PREPARED FOR THE PLAN COMMISSION

**Project Address:** 501 Welch Avenue (District 6 – Ald. Rummel)  
**Application Type:** Rezoning  
**Legistar File ID #:** [38743](#)  
**Prepared By:** Kevin Firchow, AICP, Planning Division  
Report Includes Comments from other City Agencies, as noted  
**Reviewed By:** Jay Wendt, Principal Planner

**Requested Action:** Approval to rezone 501 Welch Avenue from the TR-C2 (Traditional Residential-Consistent 2) to the TR-C3 (Traditional Residential-Consistent 3) District.

EXHIBIT 1

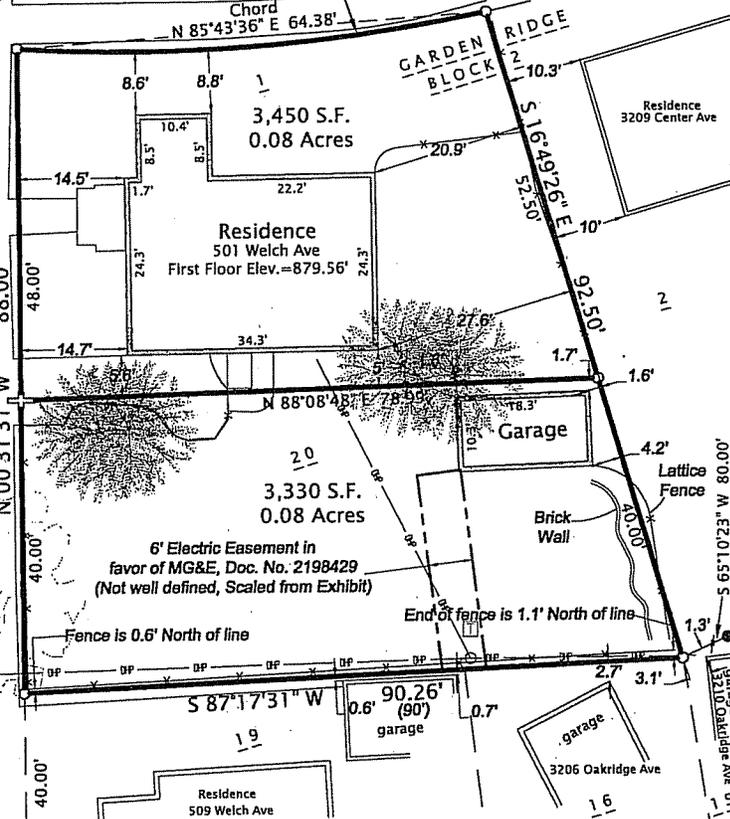
1. A plat of Survey by Isthmus Surveying LLC has been completed of the two Lots adequately monumenting the boundaries of each Lot. Refer to Dane County Surveyor's Office Map No.'s 2015-00336 and 2015-00404.

3. Prior to approval, verify the location of the existing sanitary sewer service. The service to the existing residence may cross onto the proposed lot. If so, this conflict would need to be resolved.

- 8. The driveway off Welch Ave. shall be closed, and a new driveway shall be re-aligned to serve lot 20. Lot 1 may have only one driveway opening.
